ISSUE DATE: 7-9-73

SCHEMATIC DIAGRAM
PS163 DUAL TRACE TRIGGERED OSCILLOSCOPE

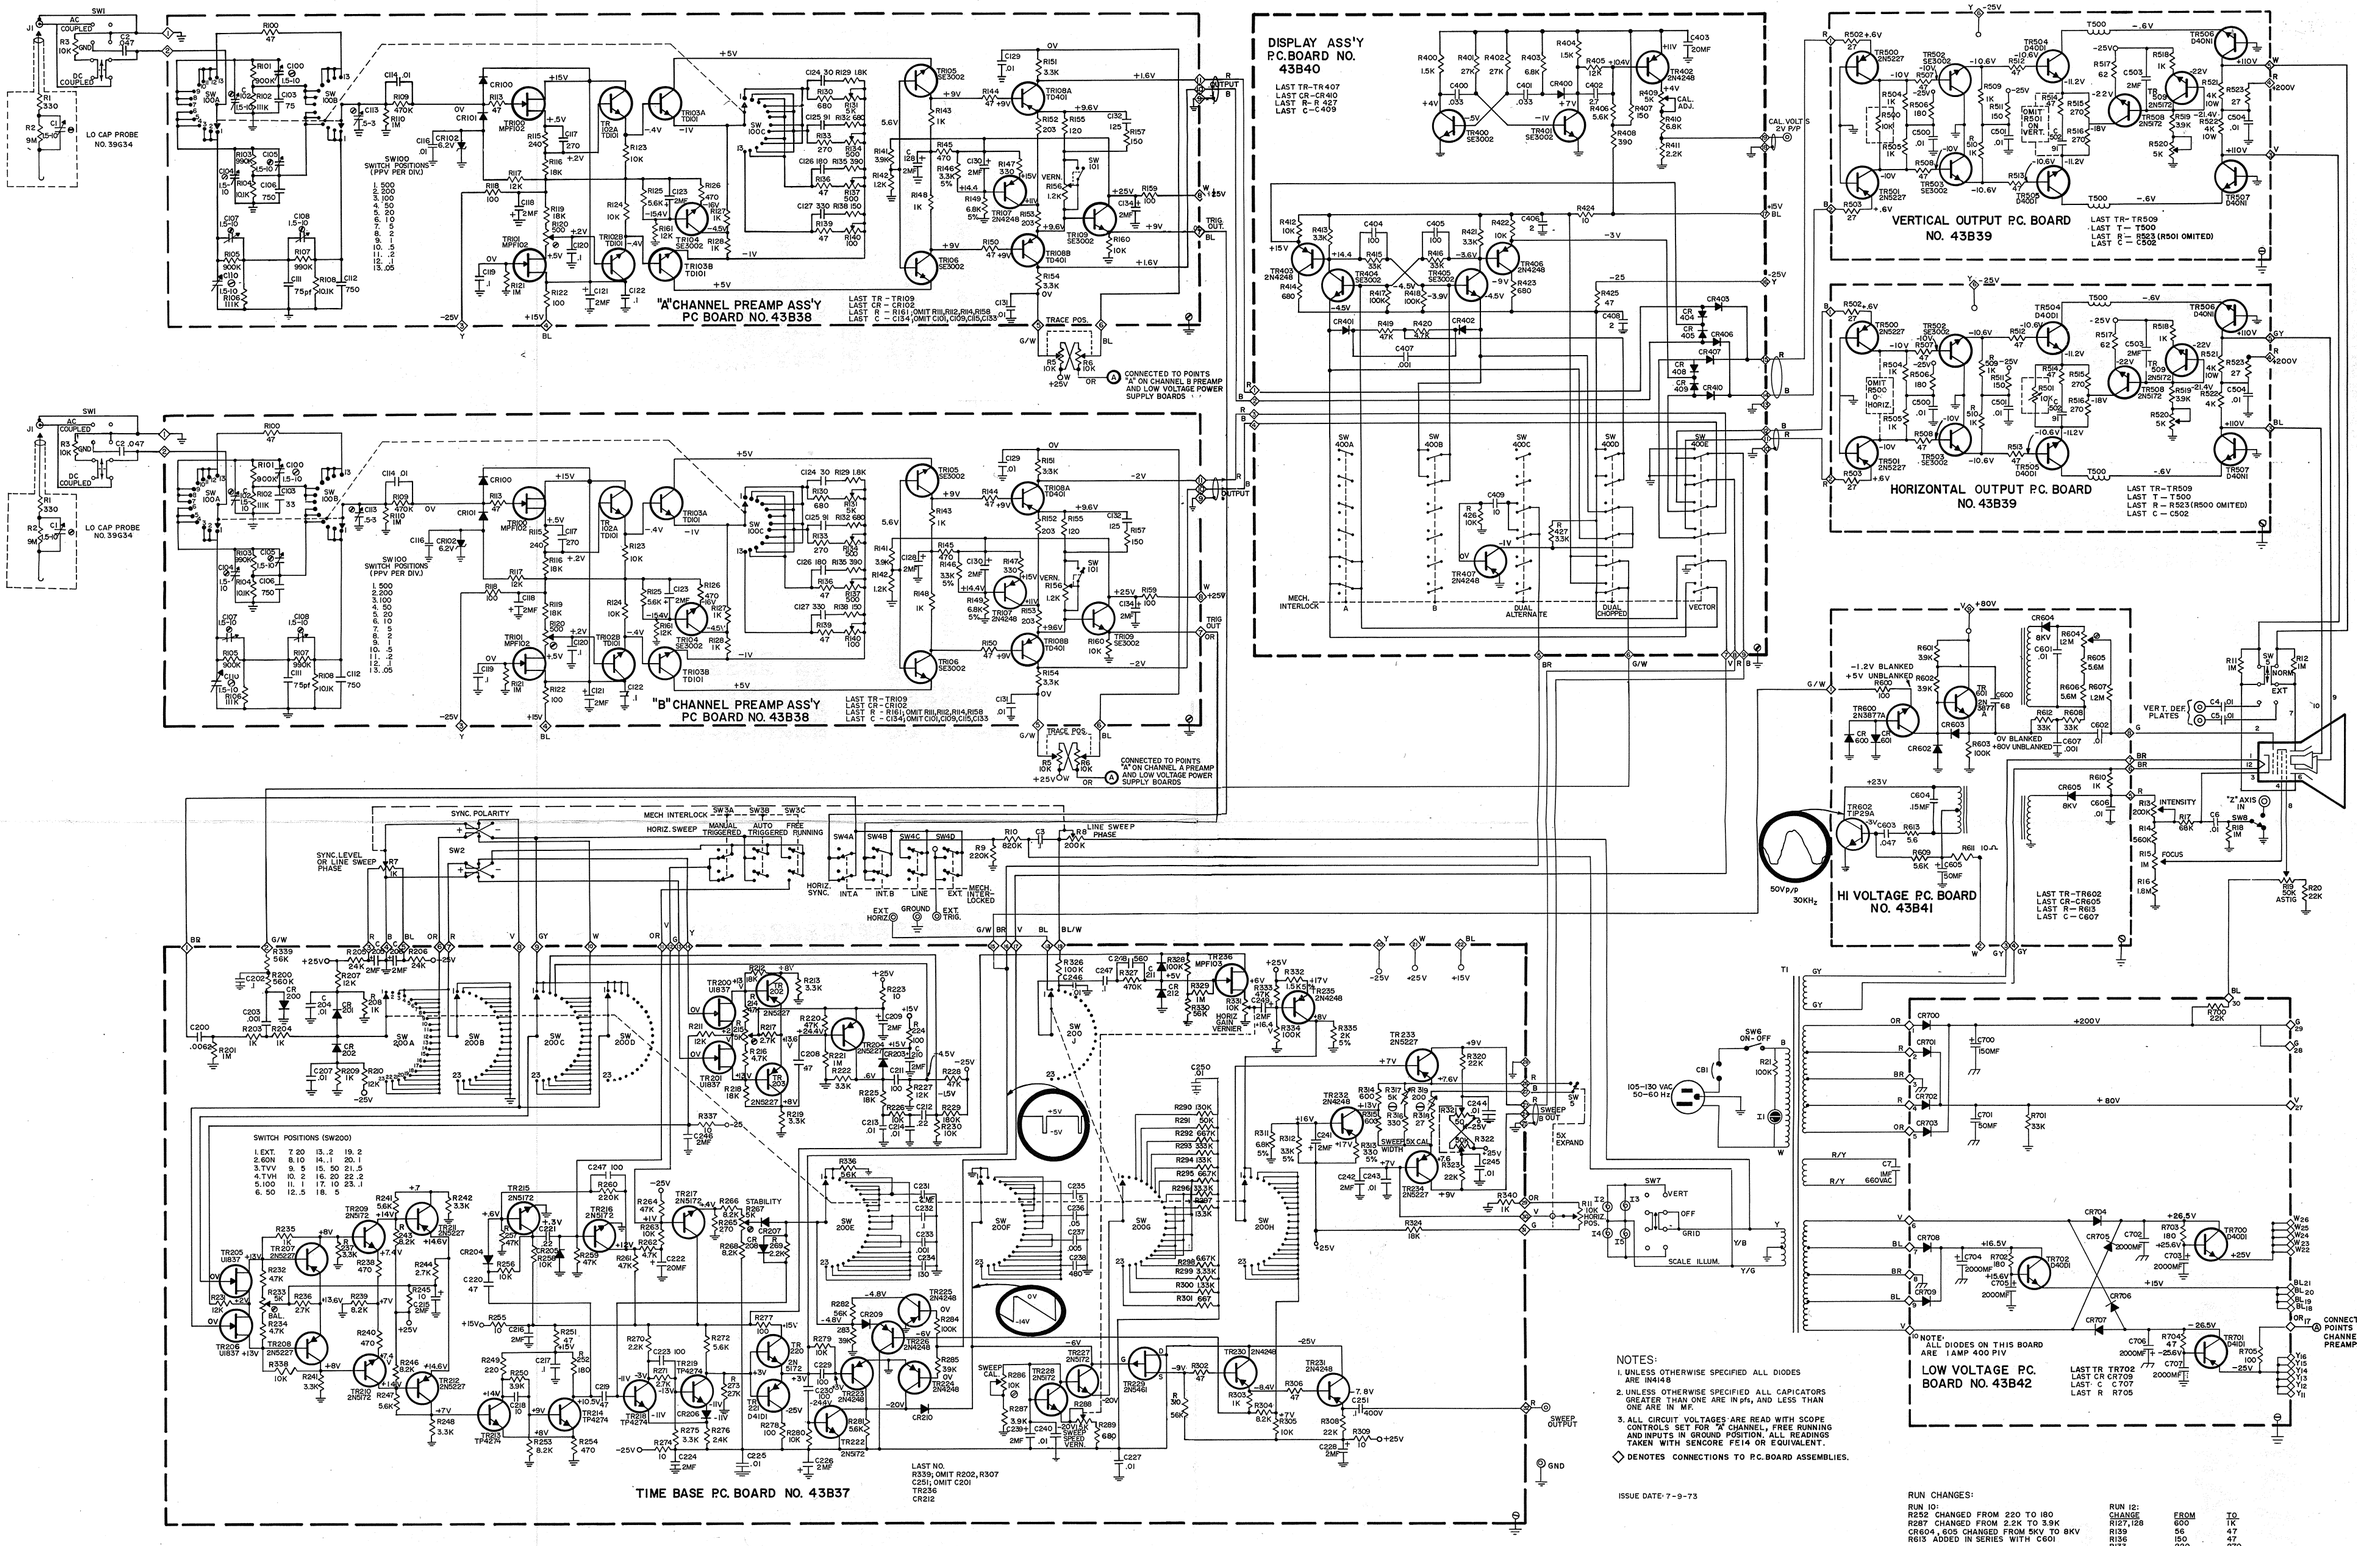
RUN 10:
R252 CHANGED FROM 220 TO 180
R287 CHANGED FROM 2.2K TO 3.9K
CR604, 605 CHANGED FROM 5KV TO 8KV
R613 ADDED IN SERIES WITH C601

RUN 11:
R336 CHANGED FROM 180K TO 56K
R340 (INCORRECTLY LABELED ON PC BOARD AND ORIGINAL SCHEMATIC AS R235) CHANGED FROM 2.2K TO 1K
C406, 408 CHANGED FROM .1uf TO 2uf

RUN 12:

CHANGE	FROM	TO
R127, 128	600	1K
R139	56	47
R136	150	47
R133	220	270
R130	2.7K	680
